CONTAMINATION ASSESSMENT WORK PLAN SITE UST 1343 NS MAYPORT FL
8/27/1998
BHATE ENVIRONMENTAL ASSOCIATES, INC.

CONTAMINATION ASSESSMENT WORK PLAN – SITE UST-1343
NAVAL STATION MAYPORT
MAYPORT, FLORIDA
CONTRACT NO.: N62467-96-D-0976
BEA PROJECT NO: 9970058

RE: Draft Contamination Assessment Report Tank Site 1343, Naval Station Mayport, Mayport, FL

Figure 1

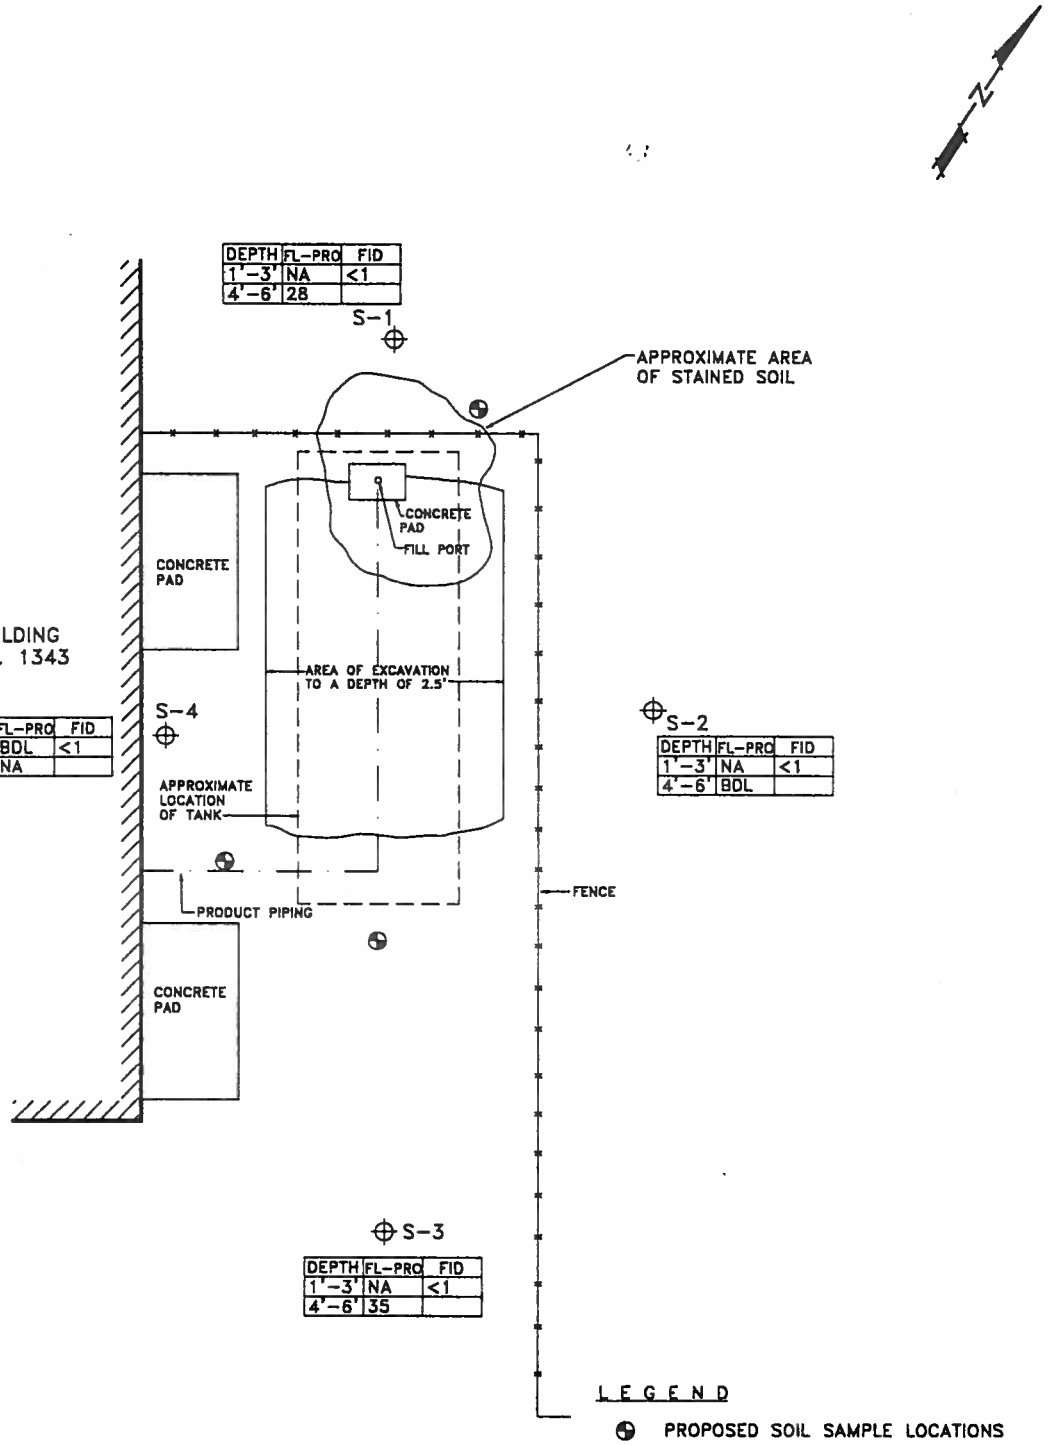
3. Please confirm the disposition of the former product piping. Was it removed or is it still operational? Please obtain one soil boring midway between the end of the tank and Building 1343, along or in close proximity to the piping or its former location. If contamination is noted, obtain additional borings, sufficient to characterize any contamination. Additionally, obtain soil borings along the existing fuel line, the 12" water line and the sanitary sewer line in order to assess the possible migration of contamination along their pathways. If contamination is noted, please obtain additional borings which will sufficiently characterize any possible soil contamination.

1) If the currently proposed soil sampling locations indicate FID readings greater than 10 parts-per-million, additional hand auger borings will be advanced as needed until soil contamination is defined based on FID readings.

The G.B. Robbins closure report indicated soil contamination at the ends of the tank. Contamination was not found along the sides of the tank, nor was it encountered near the sewer line. The 12-inch water line is inaccessible due to surface structures. Therefore, Bhate proposes to conduct soil sampling near each end of the tank and near the product line.

A stainless steel hand auger will be used to collect soil samples near the UST and product line. The proposed soil sample locations are indicated on Figure 1. The proposed locations are approximate and may be adjusted during installation, depending on field conditions.

Figure 2

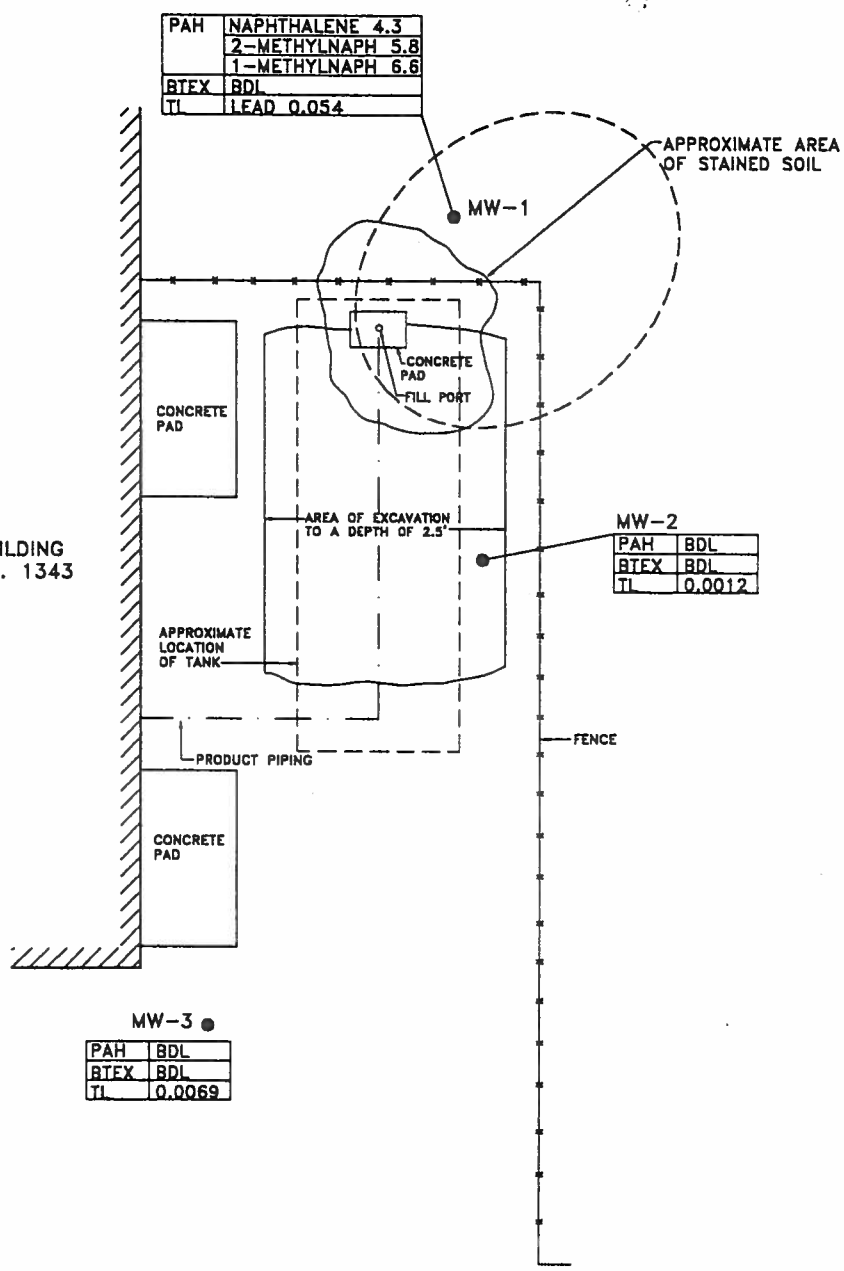
5. Detection limits for five semivolatile constituents in ground water were above regulated limits. Monitoring well MW-1 exhibited naphthalene contamination. Additionally, TRPH was not determined and lead was present above the Florida standard. Please resample MW-1 for semivolatile constituents, lead and TRPH, ensuring that the detection limits for compounds with regulatory guidelines or standards are low enough to allow the results to be utilized for determining the presence or absence of contamination.

3) Monitoring well MW-1 will be retested for semi-volatile organic compounds in addition to the previously proposed TPH and lead testing.

Additional monitoring wells are not recommended, since existing well MW-1 is within 5 feet of the northeast corner of the tank pit. Groundwater samples will be collected from MW-1 for analysis of TRPH and Lead. SVOC analysis is not recommended since previous testing using FDEP approved methodology did not indicate SVOC at the method detection limit.

NOTE: RESAMPLE MW-1 FOR TPH AND LEAD (LOW FLOW)
